Amendments to the Drawings:

REMARKS/ARGUMENTS

Targa Roof System for a Vehicle and Vehicle
Winfried Bunsmann et al. Docket No. 016382-9012
Replacement Sheet

Fig. 7

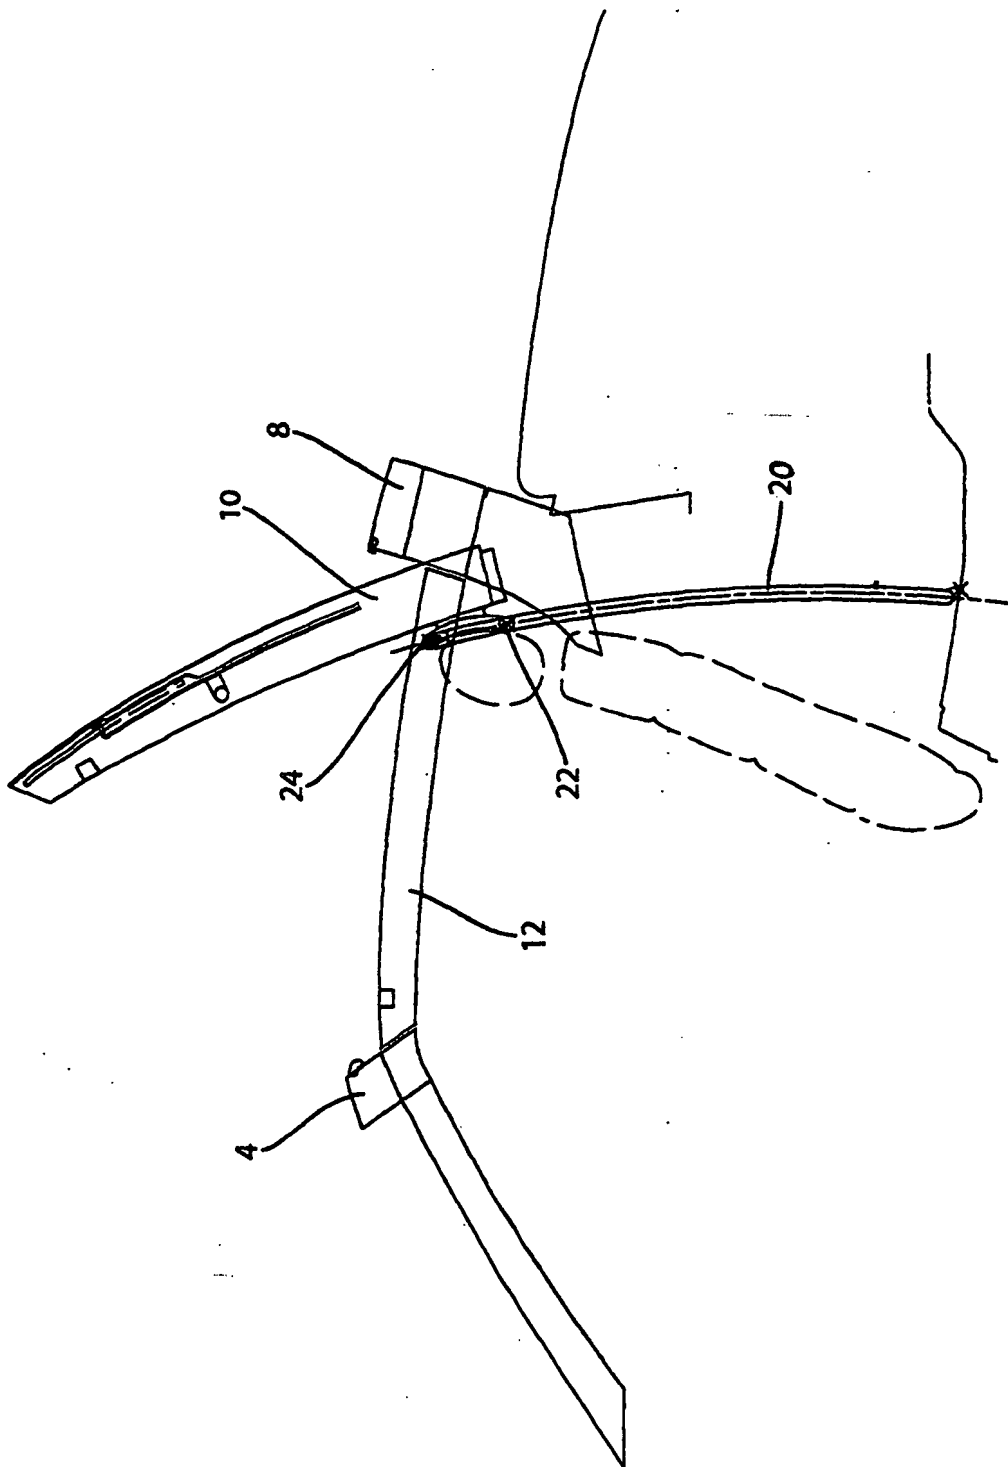
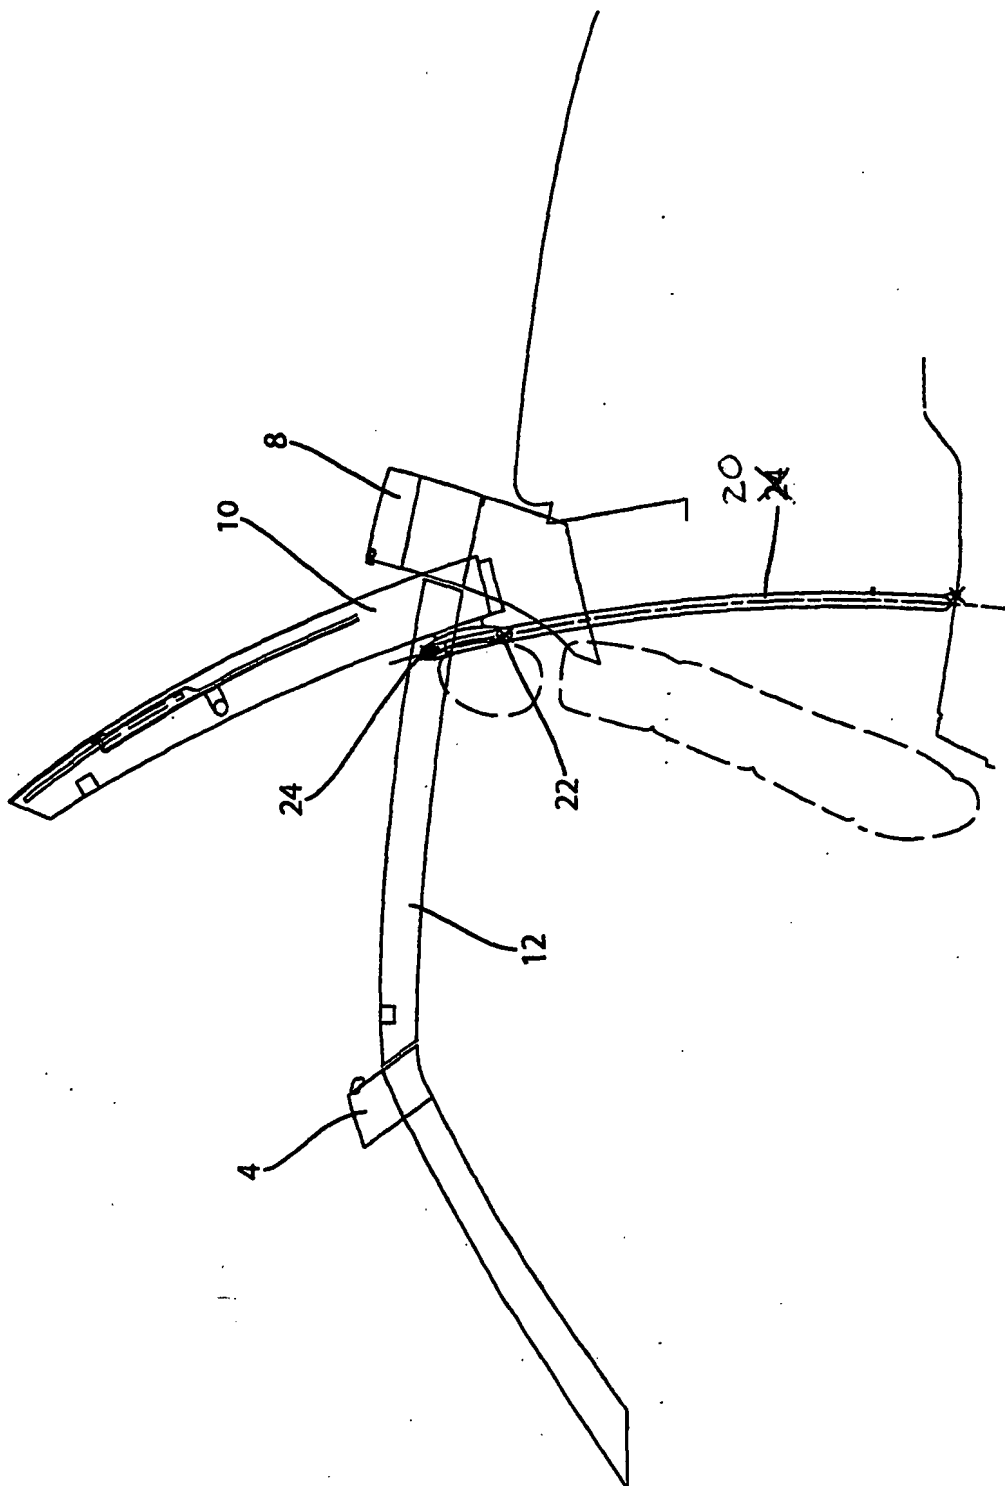
Figure 7 has been amended to correct a typographical error by replacing reference number 24, which is located between reference numbers 4 and 10, with reference number 20, as was requested in paragraph 4.a. of the Office Action mailed February 5, 2007.

In paragraph 4a of the Office Action, Figure 7 was objected to and in paragraph 4b of the Office Action, Figures 10 and 11 were objected to. Corrections to these drawings have been made according to the suggestions of the Examiner and replacement sheets for these three Figures are enclosed with this filing. Therefore, it is believed that these objections have been overcome.

Fig. 10

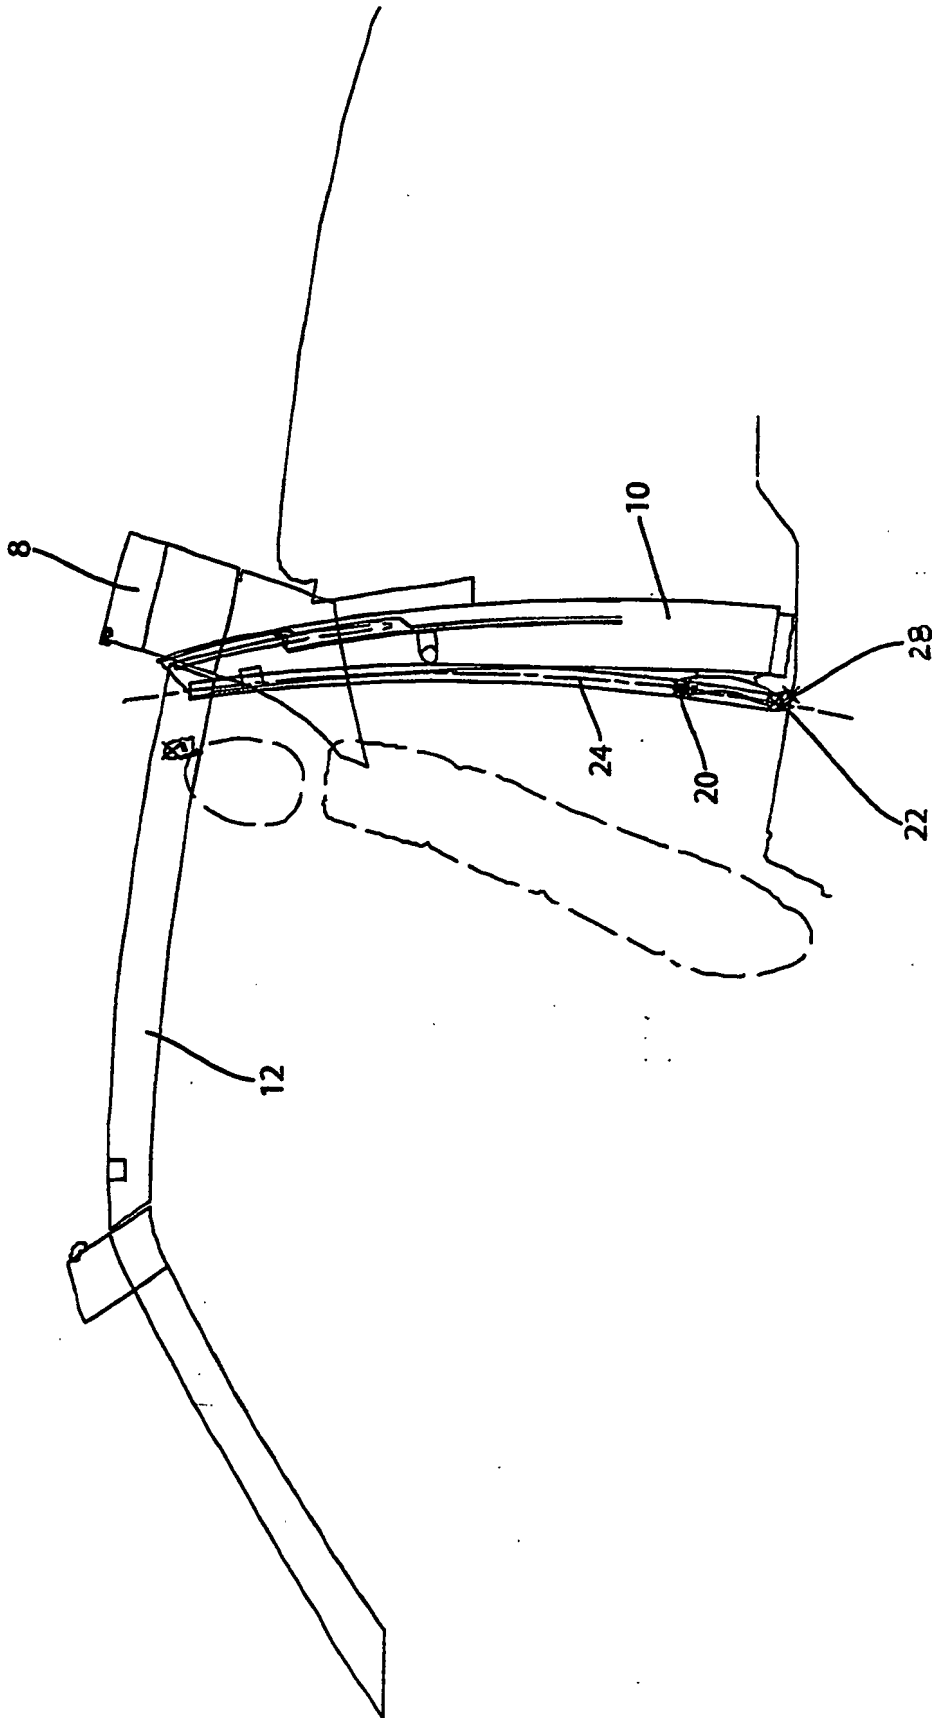
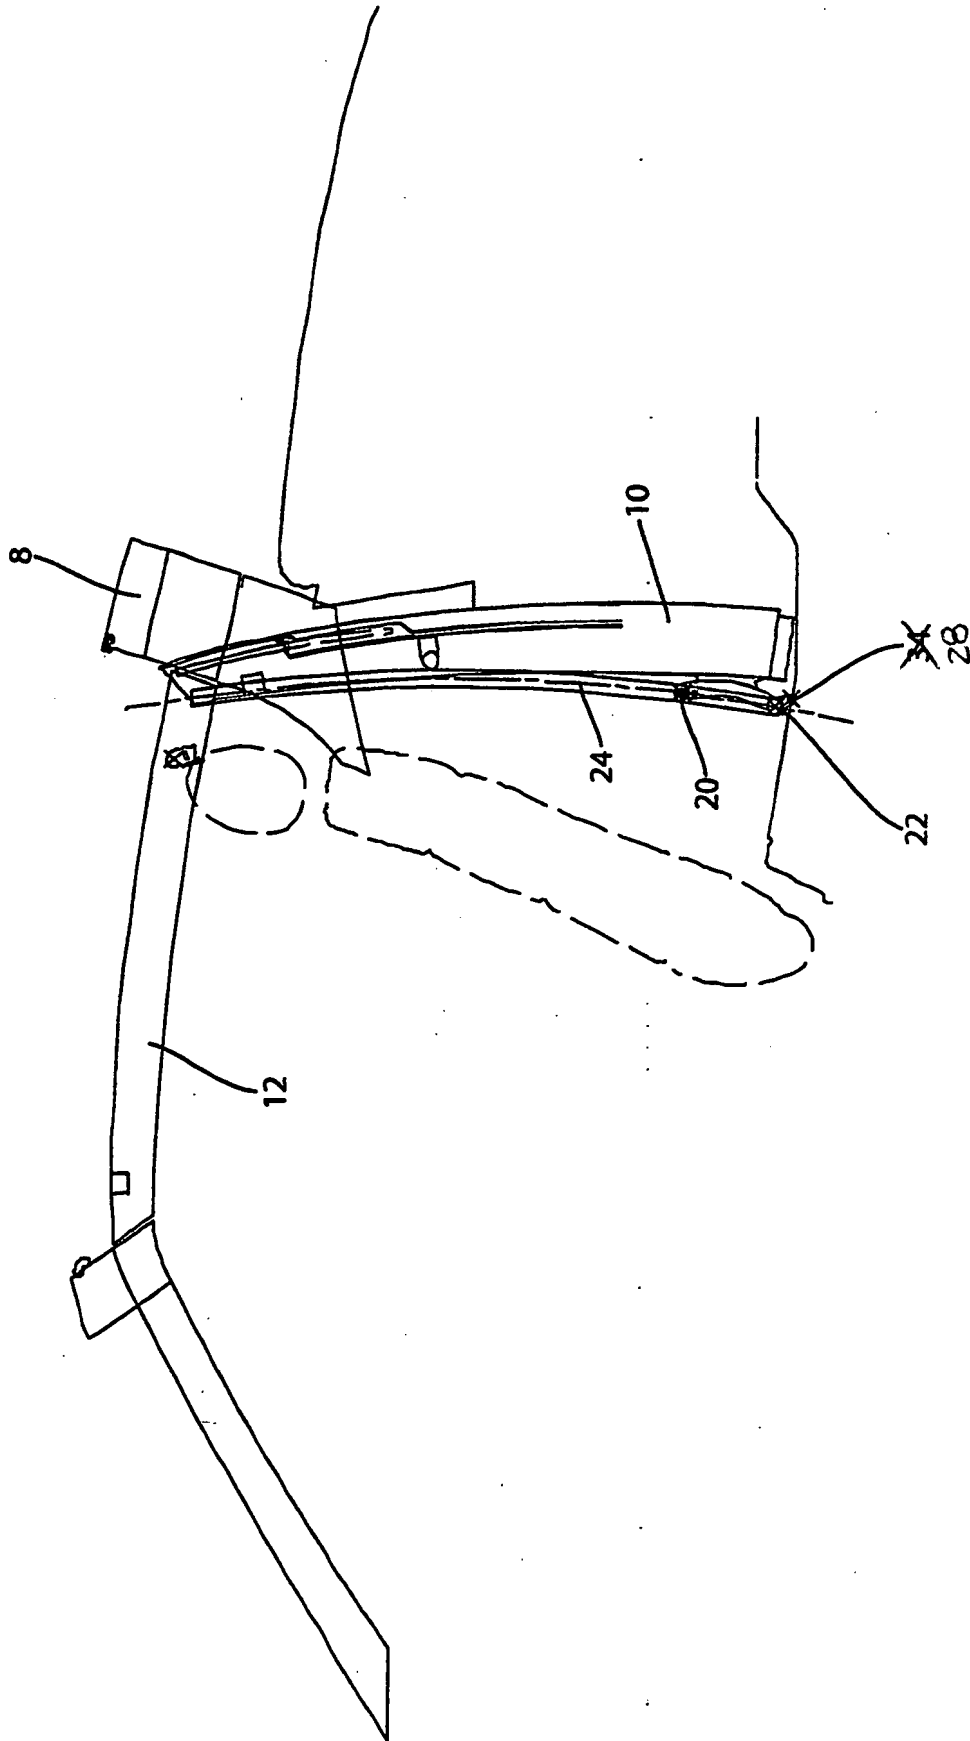
Figures 10 and 11 each have been amended to correct a typographical error by replacing reference number 34 with reference number 28, as was requested in paragraph 4.b. of the Office Action mailed February 5, 2007.
